## REVISION TRANSMITTAL

This sheet transmits Revision 1 to SL680A-30-01, which:

ICE AND RAIN PROTECTION - ADD SEALANT BETWEEN PICCOLO TUBES AND LANDING LIGHT BOX FASTENERS TO PREVENT CHAFING

680A (Citation Latitude)

Figure 1. Piccolo Tube Sealing (Sheet 1)

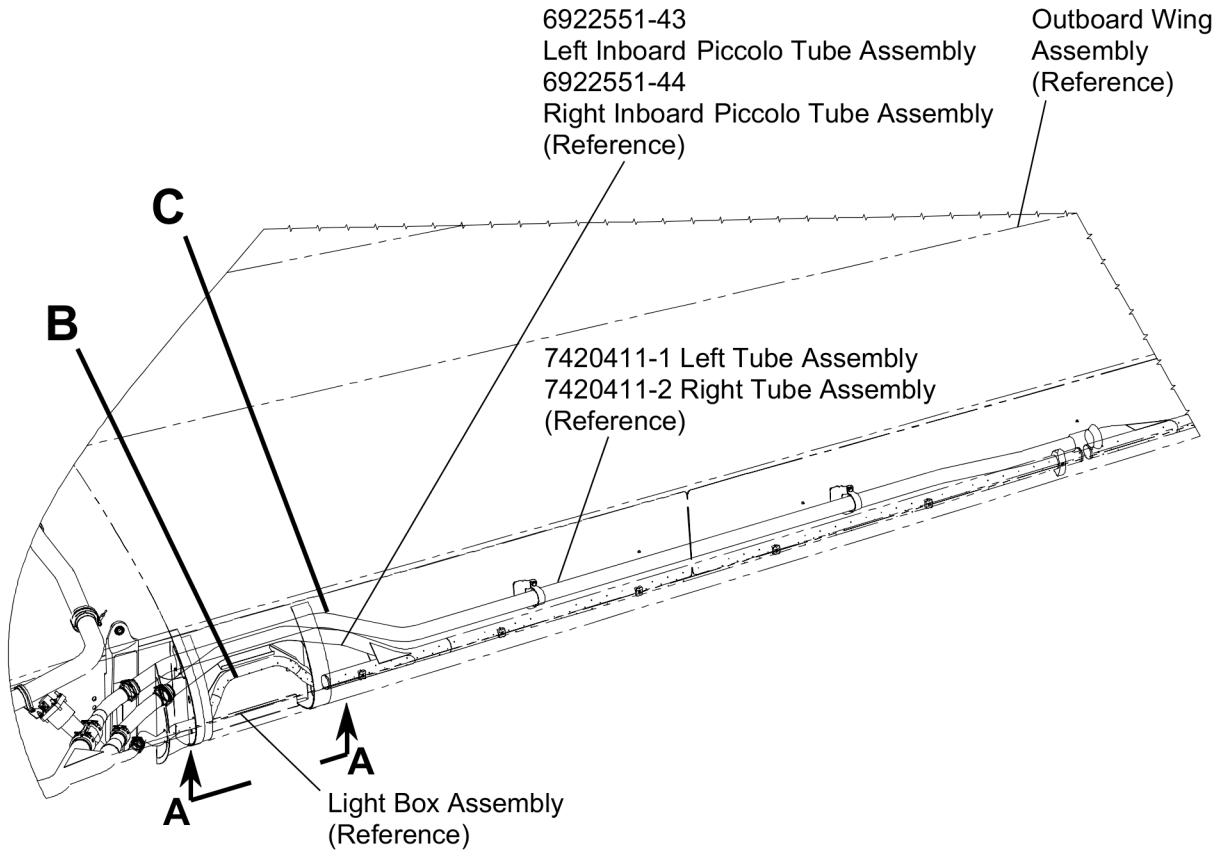
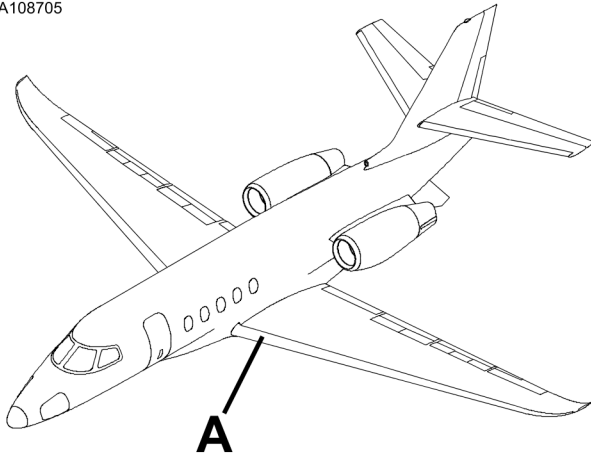
- (6) Go to Step 5.
4. (Refer to Figure 1, Detail A, View A-A and View B-B.) Inspect for sealant between the 6922551-43 Left, 6922551-44 Right Inboard Piccolo Tube Assembly and the 7420411-1 Left, 7420411-2 Right Tube Assembly where the tubes come together above the light box assembly.

- B. (Refer to Figure 1, View A-A.) If there is not a fillet seal between the 6922551-43 Left, 6922551-44 Right Inboard Piccolo Tube Assembly and the 7420411-1 Left, 7420411-2 Right Tube Assembly, do the following step.

- (1) Fillet seal between the 6922551-43 Left, 6922551-44 Right Inboard Piccolo Tube Assembly and the 7420411-1 Left, 7420411-2 Right Tube Assembly with U065012S (Type V, Class B) Sealant. (Refer to the Citation Standard Practices Manual, Chapter 20, Fuel, Weather, Pressure and High Temperature Sealing - Maintenance Practices.)

Figure 1. Piccolo Tube Sealing (Sheet 2)

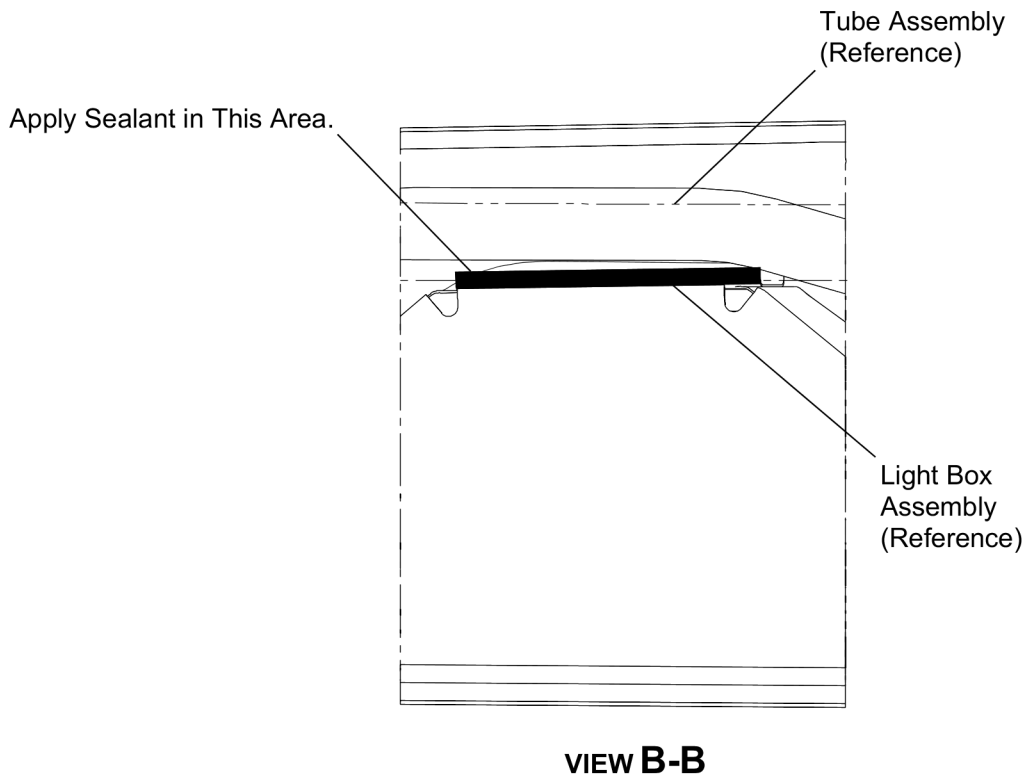
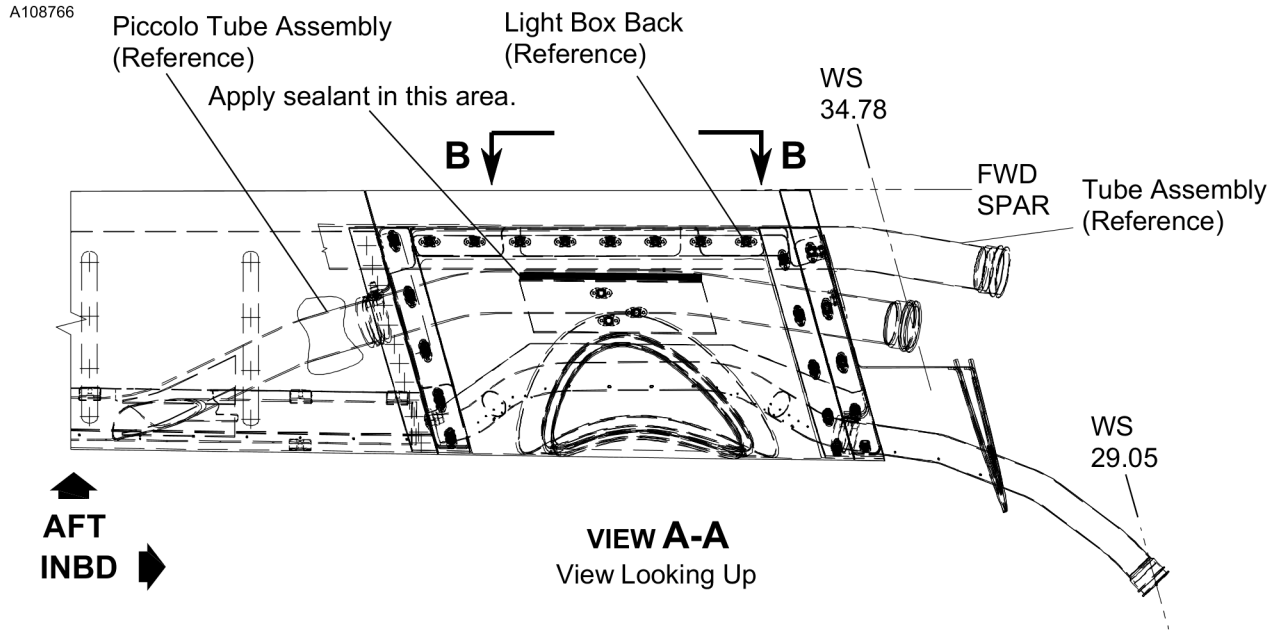
6. Install the left and right landing light. (Refer the Model 680A Maintenance Manual, Chapter 33, Landing Light - Removal/Installation.)
  7. (Refer to Figure 1, Detail A, View A-A and View B-B.) Fillet seal between the fasteners on top of the 6922530-35 Left, 6922530-36 Right Light Box Back and the 7420411-1 Left and 7420411-2 Right Tube Assembly with U065013S, (Type V, Class B) Sealant. (Refer to the Citation Standard Practices Manual, Chapter 20, Fuel, Weather, Pressure and High Temperature Sealing - Maintenance Practices.)

Figure 1. Piccolo Tube Sealing (Sheet 3)

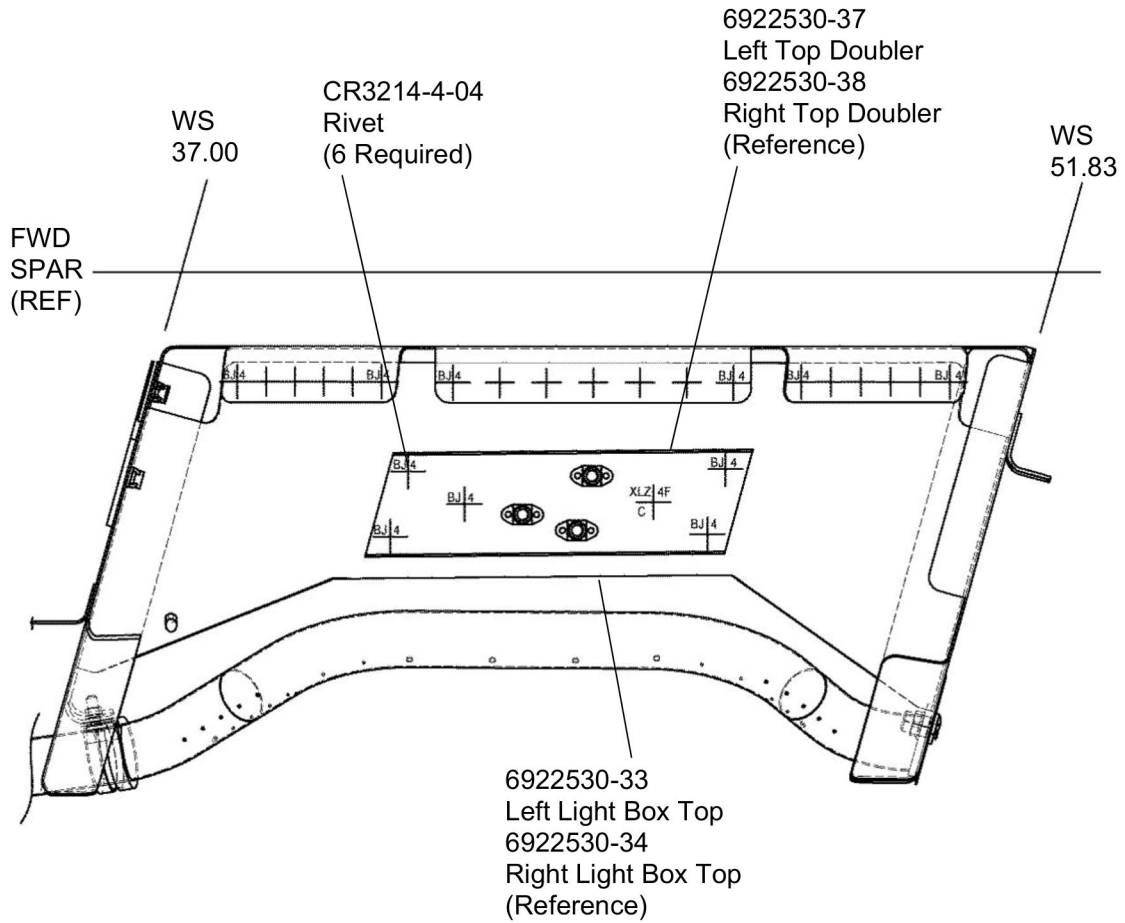
- B. Remove the left and right landing light. (Refer to the Model 680A Maintenance Manual, Chapter 33, Landing Lights - Removal/Installation.)
  - C. (Refer to Figure 1, Detail B.) Remove the left and right top doubler.

- (2) Allow the sealant to cure for 24 hours.
    - C. Go to Step 5.
5. (Refer to Figure 1, Detail A and Detail B.) Install the left and right top doubler.

- A. Put the top doubler on the light box top.
    - B. Attach the top doubler to the light box top with the kept screws and six CR3214-4-04 Rivets.

Figure 1. Piccolo Tube Sealing (Sheet 4)

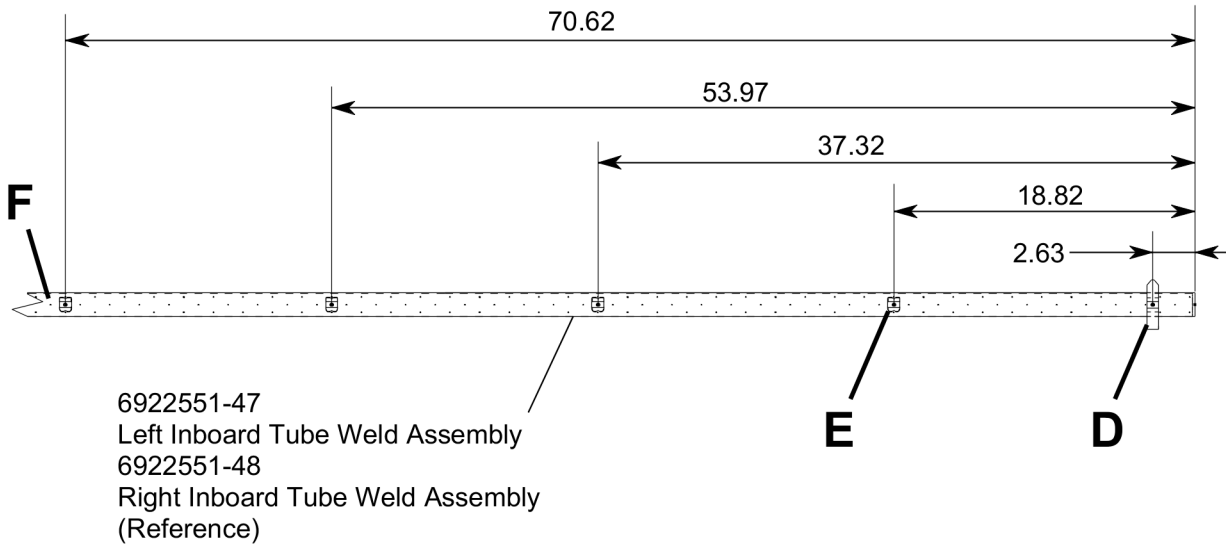
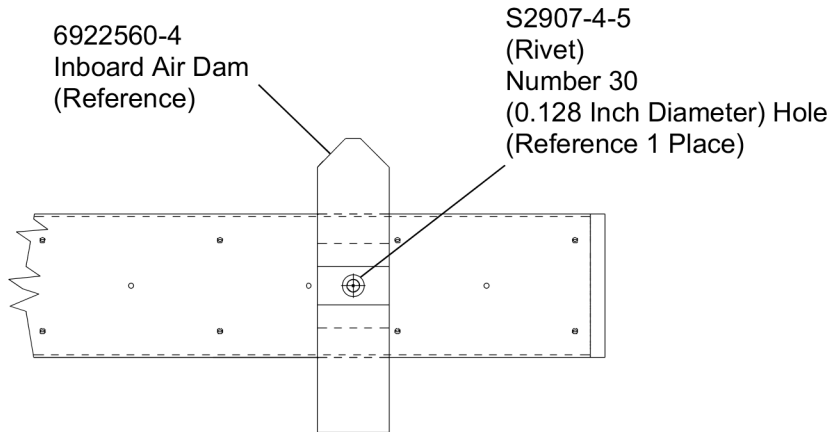
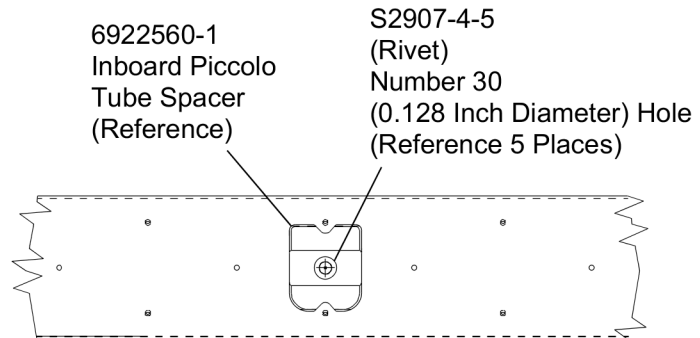
- A. Adds Step 2 to remove access panels 153BL and 154BR.
- B. Adds Step 3 to inspect for chafing between the tube assemblies and replace them, if necessary.
- C. Adds Step 4.B.(2) to allow the sealant to cure for 24 hours.
- D. Adds Step 5 to install the top doubler.
- E. Adds Step 6 to install the left and right landing light.
- F. Adds Step 7.A. to allow the sealant to cure for 24 hours.
- G. Adds Step 8 to install access panels 153BL and 154BR.
- H. Adds the table to the MATERIAL INFORMATION section.
- I. Adds Figure 1, Sheet 3 to show removal and installation of the top doubler.
- J. Adds Figure 1, Sheet 4 and Sheet 5 to show assembly of the inboard and outboard Tube Weld Assemblies.

- (3) (Refer to Figure 1, Detail A, Detail C, Detail D, Detail E and Detail F.) If necessary, assemble the 6922551-43 Left, 6922551-44 Right Inboard Piccolo Tube Assemblies.

- (a) Put the five 6922560-1 Tube Spacers on each 6922551-47 Left, 6922551-48 Right Inboard Tube Weld Assemblies.
      - 1 Drill one Number 30 (0.128 inch-diameter) hole in each 6922560-1 Tube Spacer.

- (b) Put the two 6922560-4 Inboard Air Dams on each 6922551-47 Left, 6922551-48 Right Inboard Tube Weld Assemblies.
      - 1 Drill one Number 30 (0.128 inch-diameter) hole in each 6922560-4 Inboard Air Dam.
